**Re: Christina Lake Thermal Project Phase H and Eastern Expansion
Project Update and Supplemental Information Request 2 Responses
AER Application No. 1758947
EPEA Application No. 019-48522**

The purpose of this document is to provide responses to the Round 2 SIR package and provide updated information regarding the Project (Project Update). This document is organized into two parts as follows:

I:\CLIENTS\CENOVUS\14-1346-0011\mapping\MXD\C&R\SIR_Round2\ESRD_SIR_17_Figure_37_13.mxd

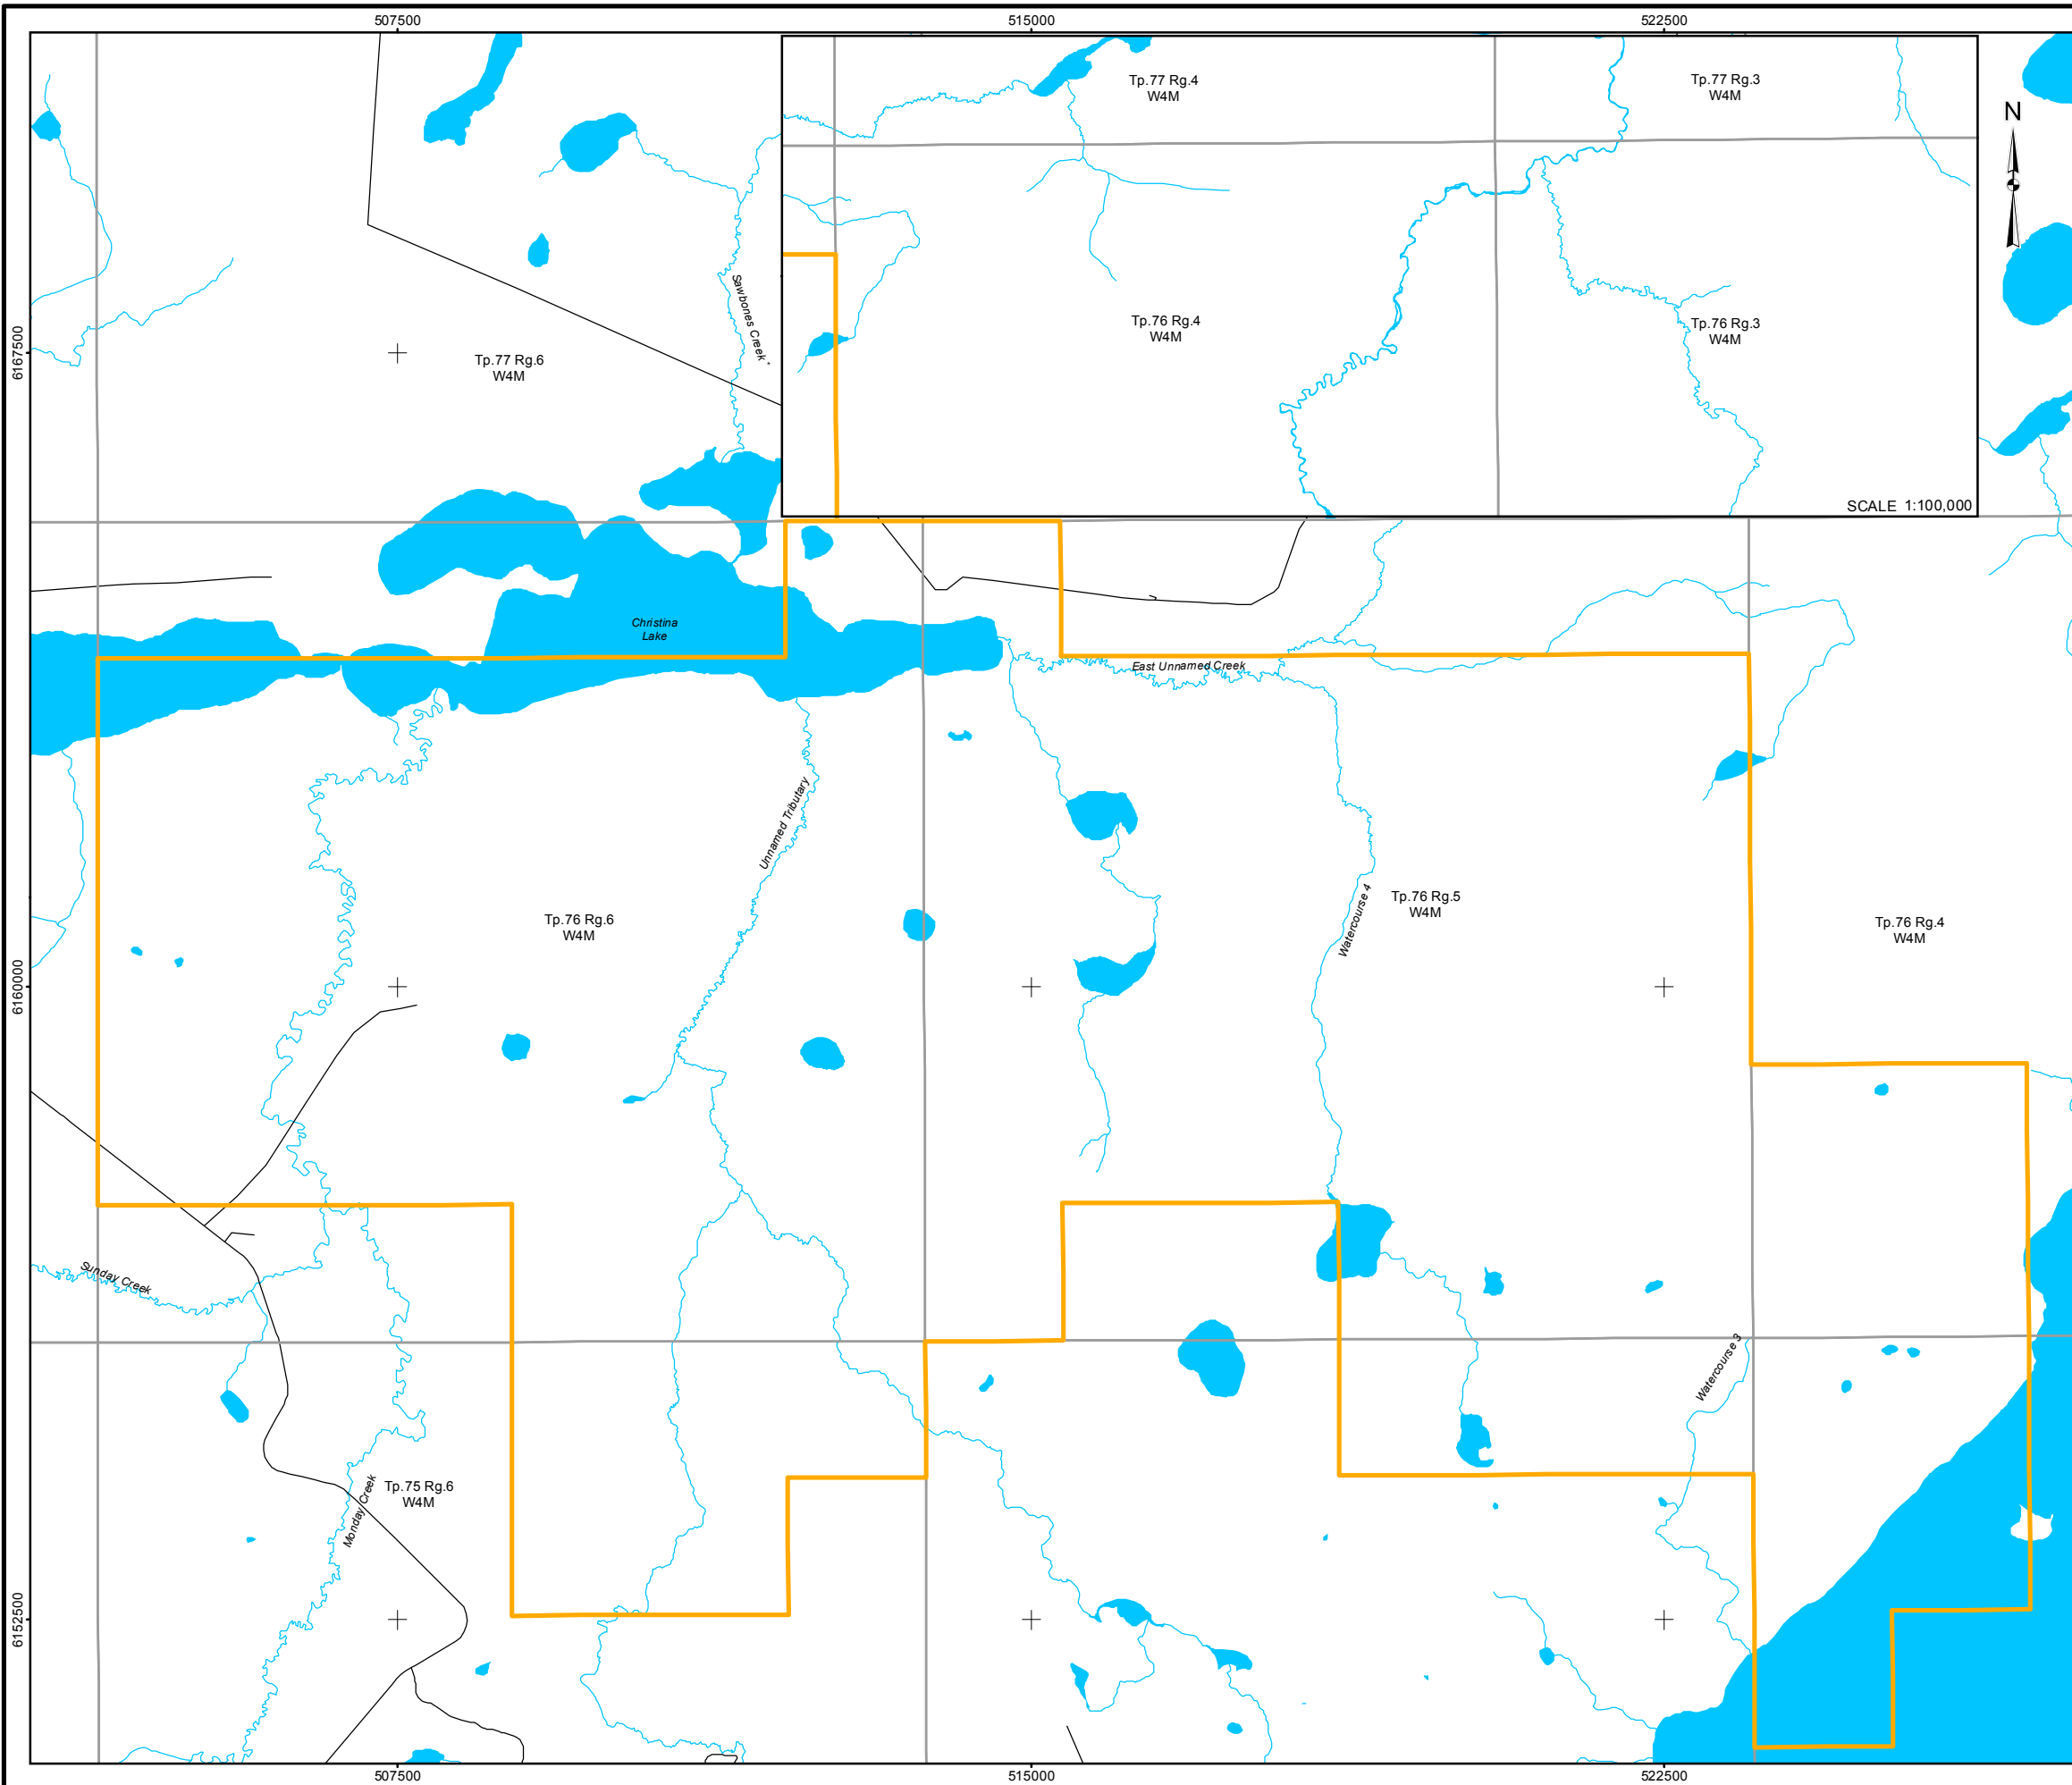
In Table 65-2, the column Unnamed (Monday) Creek appears to be mislabelled. All Figures in the SIR response 69 are mislabelled. In Figure 186-1, the sub-watershed is mislabelled.

Figures 69-1 to 69-13 from ESRD Round 1 SIR 69 have been revised and are presented as [Figures 37-1 to 37-13](#).
